**SUSQUEHANNA STEAM ELECTRIC STATION
SUPPLEMENTAL INFORMATION APPLICABLE
TO PROPOSED AMENDMENT NO. 235 TO
LICENSE NPF-14 AND PROPOSED AMENDMENT
NO. 200 TO LICENSE NPF-22: POWER UPRATE
PLA-5300**

**Docket No. 50-387
and 50-388**

The purpose of this letter is to respond to your Request for Additional Information (RAI) [Reference 1] and to describe changes to the power ascension test regime delineated in reference 1.

OVERPRESSURE PROTECTION ANALYSIS
(MSIV CLOSURE WITH HIGH FLUX SCRAM TRIP)
FSAR FIGURE 5.2-14

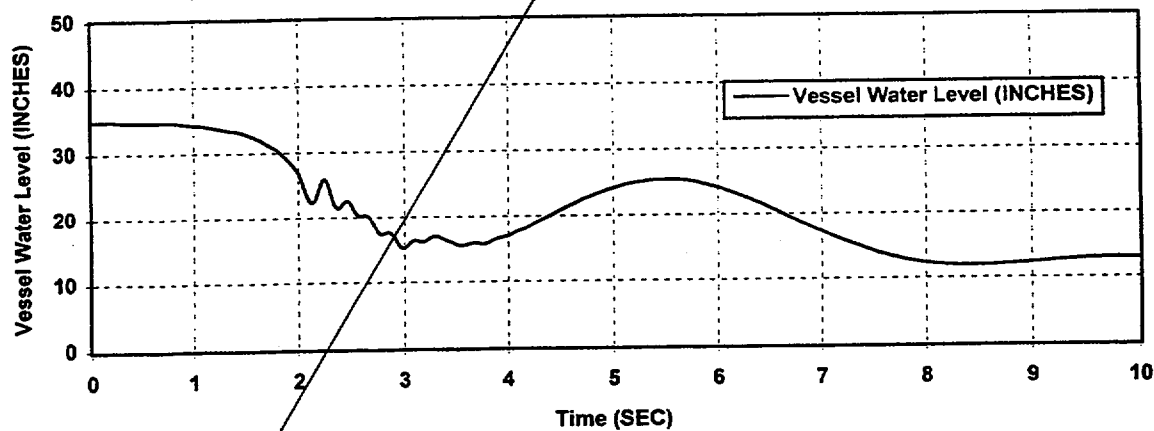
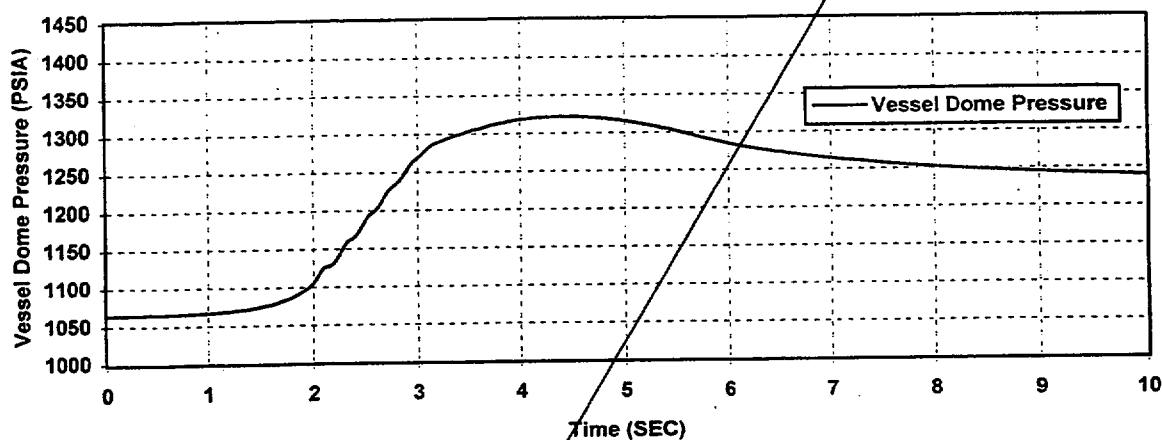
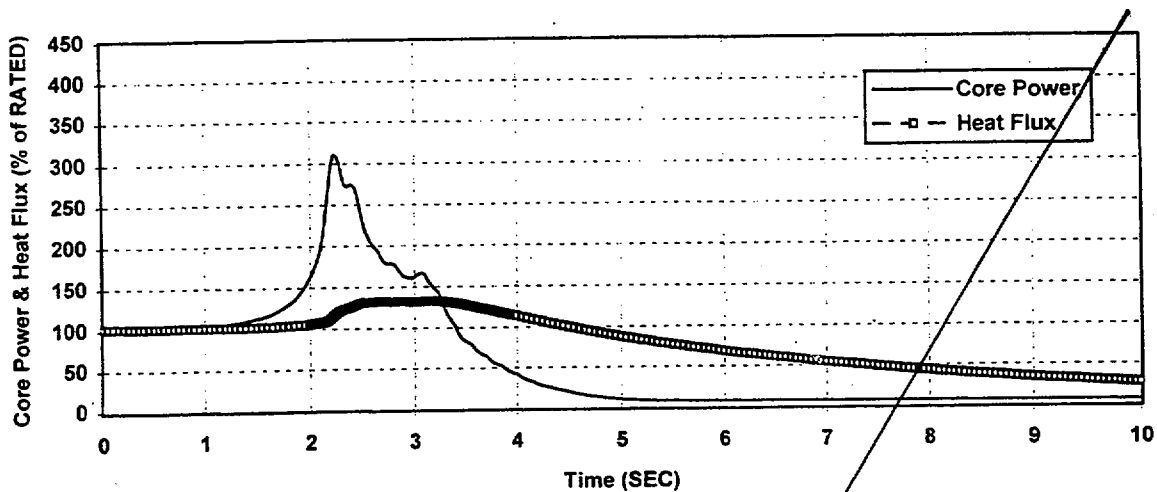
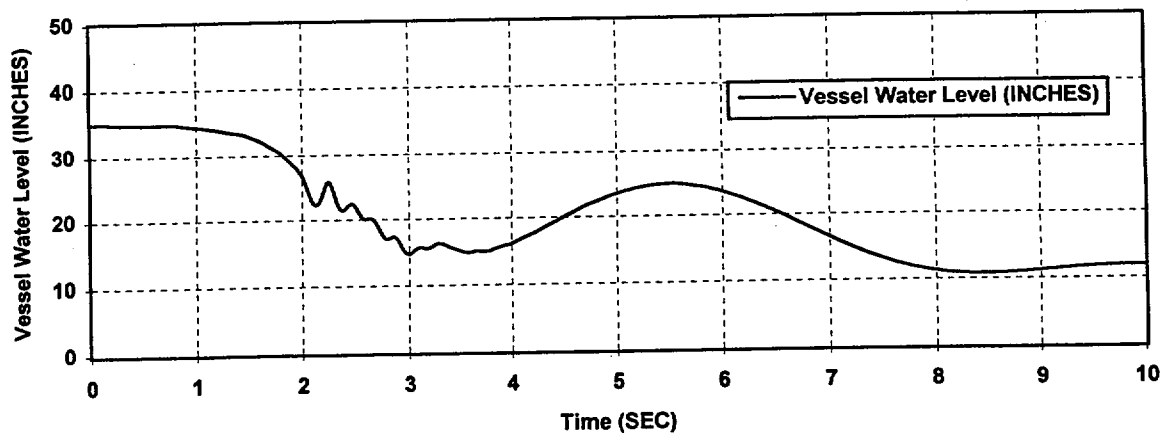
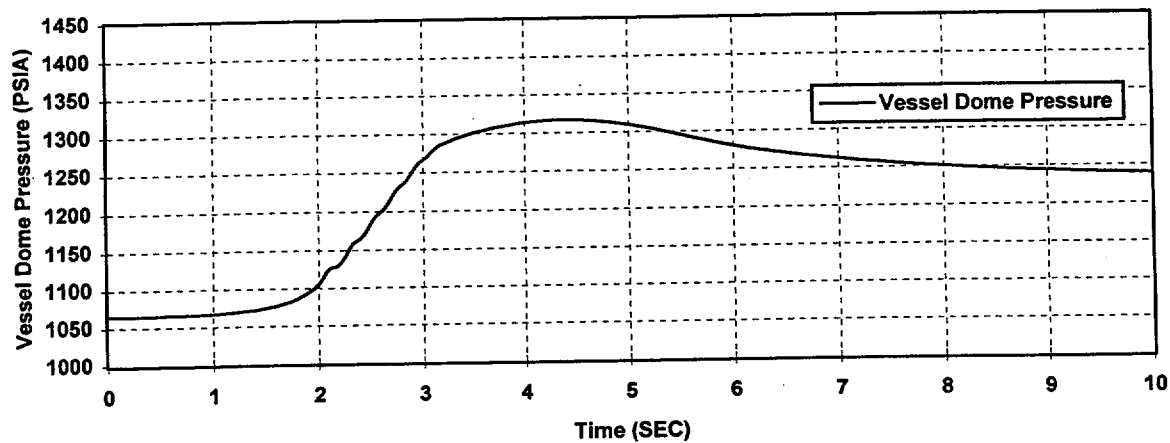
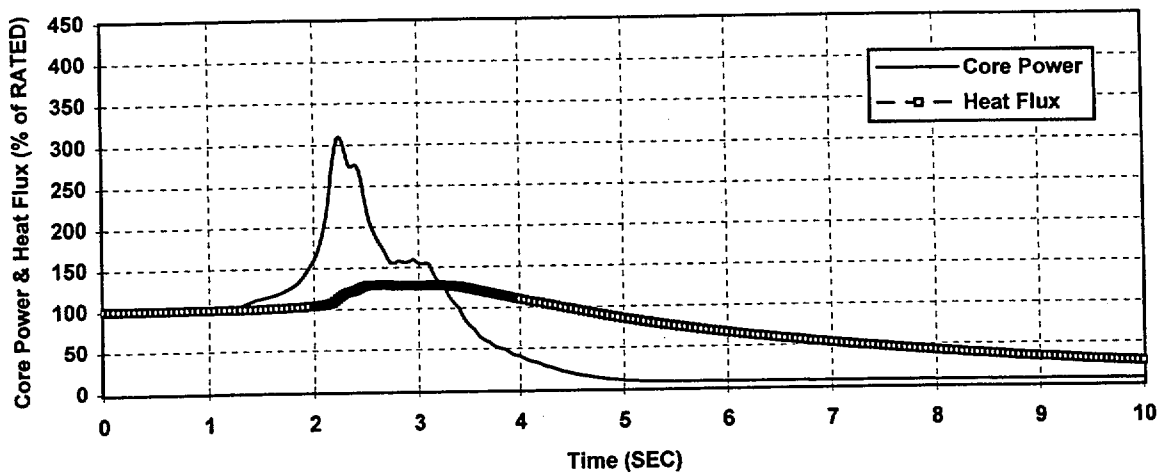
You stated in your submittal that because the uprated power does not entail an increase in the operating pressure used for evaluation, the SRV pressure setpoints do not have to be changed. Please verify that the SRV's can provide the necessary overpressure protection during limiting anticipated operational occurrence transients, ATWS transients, and American Society of Mechanical Engineers (ASME) overpressure transients.

Transient Overpressure (TOP) analysis, performed specifically for Unit 2 Cycle 11 at the uprated conditions, is documented in draft updates to Chapter 5.2 of the FSAR contained herein. This analysis demonstrates that the SRV's provide the necessary overpressure protection with respect to the TOP limits. In addition, Chapter 15 analysis has also been performed specifically for Unit 2 Cycle 11 operation at the uprated conditions, and results meet all criteria set forth in Chapter 15. Therefore, SRV setpoints do not require revision due to operation at a licensed power level of 3489 MWt.

Replace figure
